May 28, 2013
Medway Planning and Economic Development Board
155 Village Street
Medway, MA 02053

Public Hearing Continuation - Hill View Estates Definitive Subdivision Plan - 32 Hill St:

PUBLIC HEARING CONTINUATION - Tri-Valley Commons Site Plan

Re: Review of Tri Valley Commons Access Plans, 72 Main Street
Medway, Massachusetts

**MEDWAY
MAIN STREET (ROUTE 109)
PAVEMENT MARKING & SIGNING PLAN**

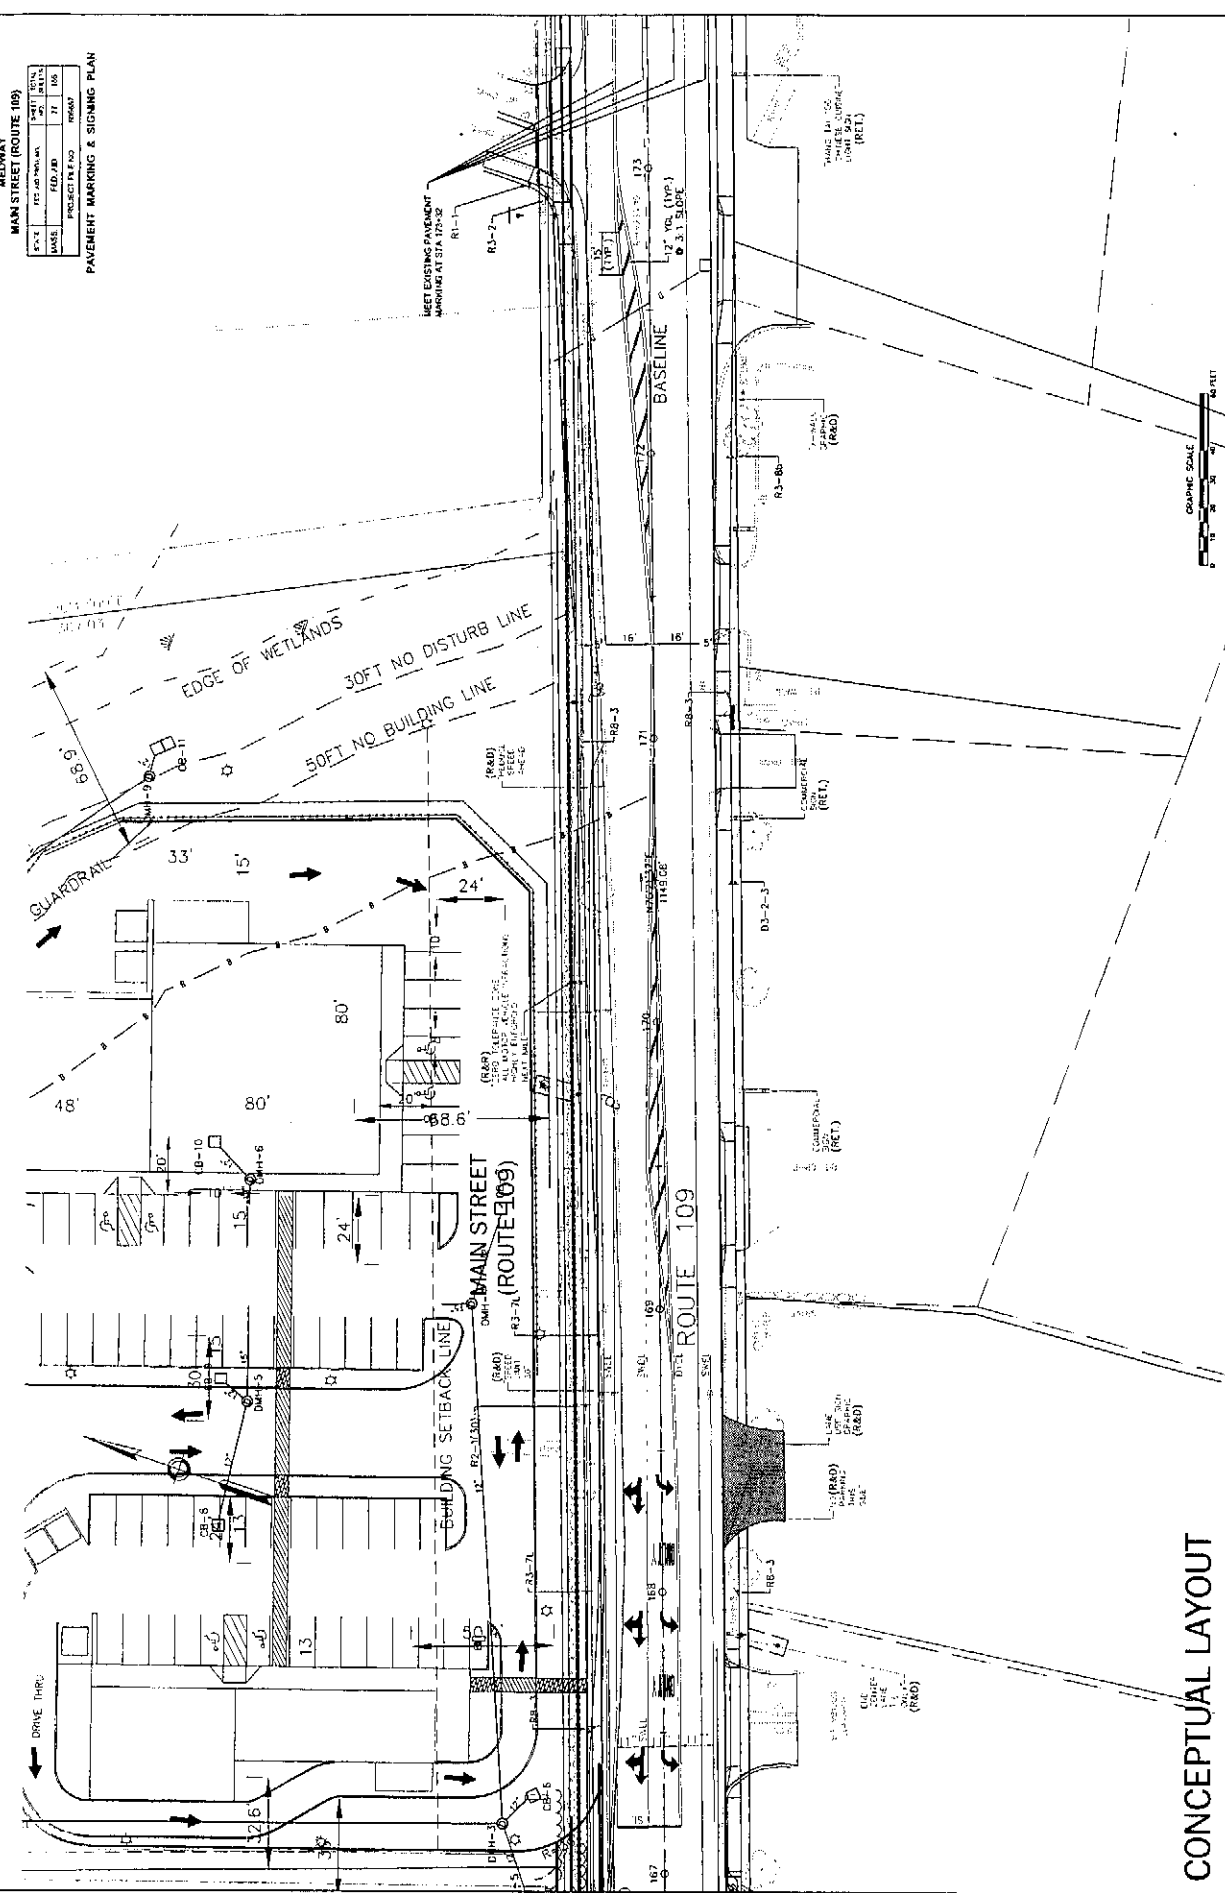
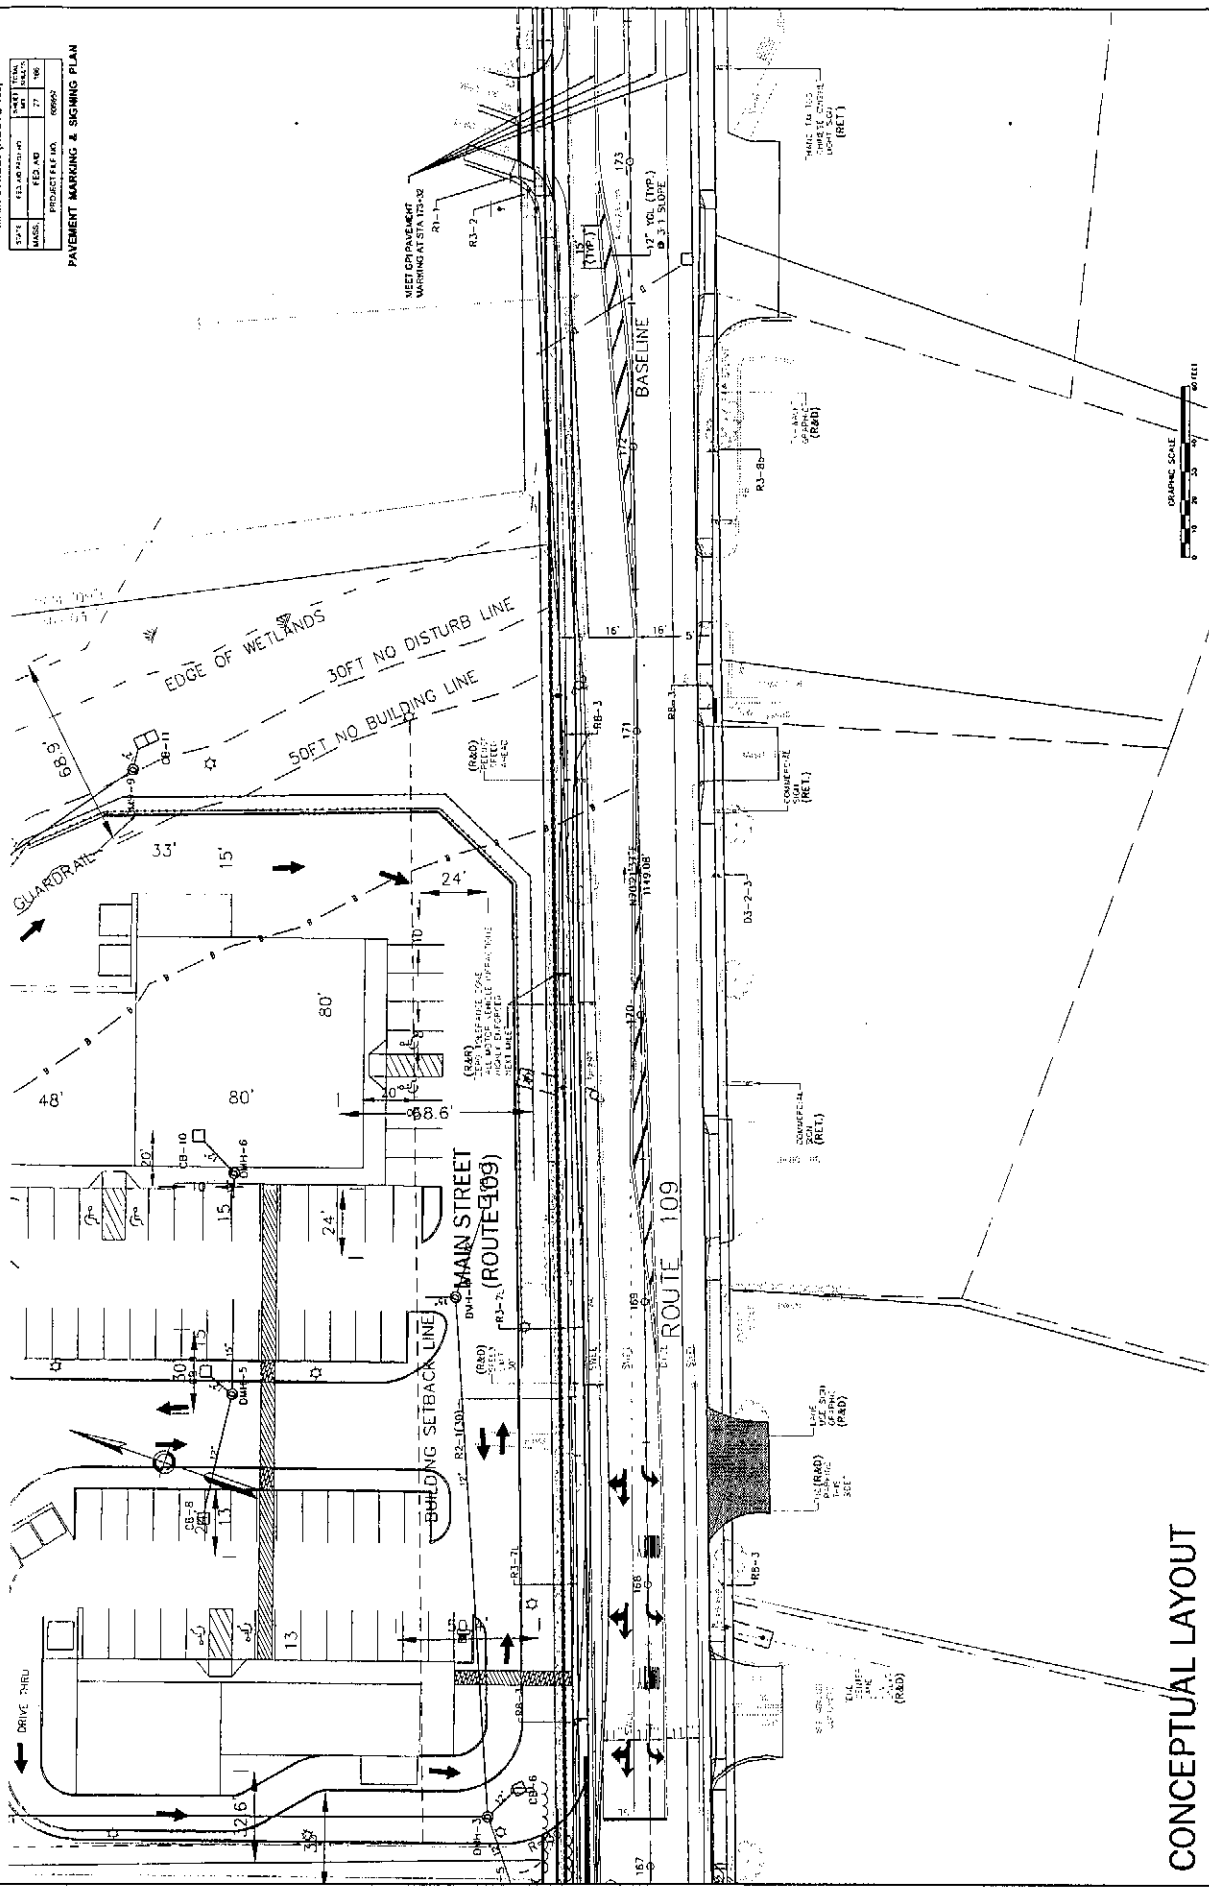
I think the one last item was to clarify the pavement markings. Along that line, I have attached two sets of markings plans: our project matching "existing"; and our plan matching the future GPI plan (that requires modifications presuming the signal location changes and this is reflected).

Site Plan Source: Green International Affiliates, Inc.

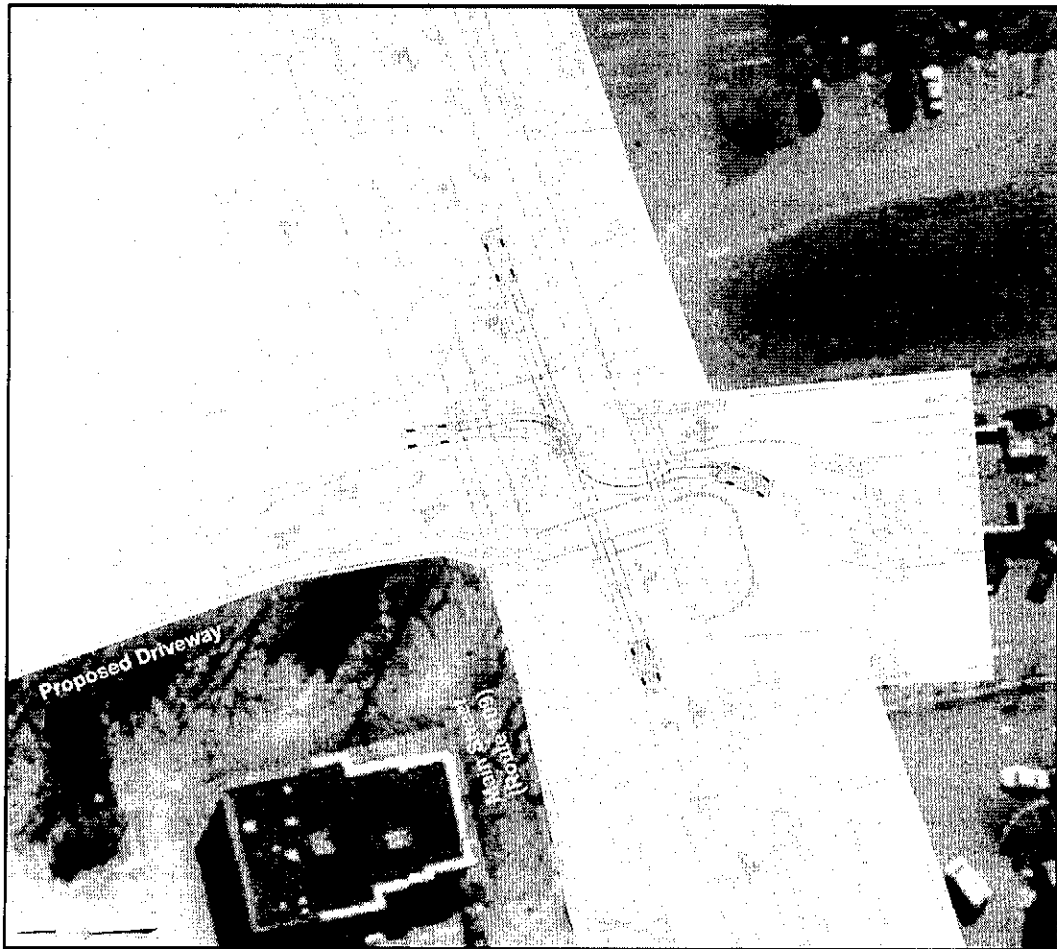
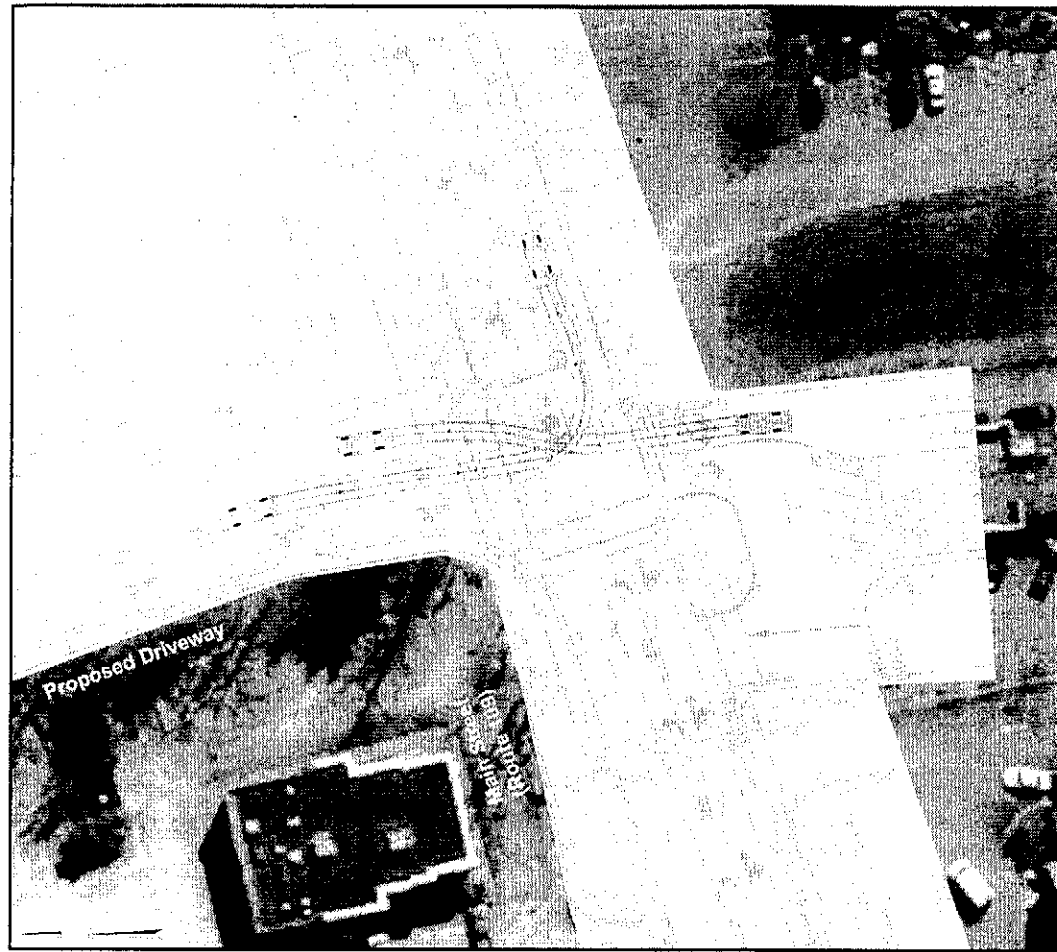
The following is a brief summary of issues/concerns relative to the currently proposed improvement plan for the Tri Valley Commons and associated analysis:

- *Lack of Pedestrian Accommodation.* The concept lacks full accommodation of pedestrian features, which should include (a) the planned sidewalk alignment on the south side of Route 109, and (b) a crossing on the east side of the intersection. Accommodation for a crosswalk on the westbound approach would require moving the Stop Line further west, effectively placing the MetroWest Health Center driveway within the confines of the signalized intersection but without the benefit of signal control.

- *Corridor Vehicle Queue Impacts.* Proximity of the signal along the corridor is incompatible with 25% design plans which propose a signal approximately 300 feet to the west at a nearby Gould’s Plaza. This placement will undermine the ability for progressive traffic flow along the corridor, as the close signal spacing will result in regular queue impacts between these planned signals during peak hours. MDM advises that one or these two signals should be eliminated on this basis. Further, the access/egress to Metrowest Health Center (81B Main Street) is effectively within the intersection at Tri Valley Commons and has not been incorporated into the traffic signal plan. The proposed traffic signal will result in queues that materially impair the ability for patients, ambulances and staff to exit left onto Route 109.
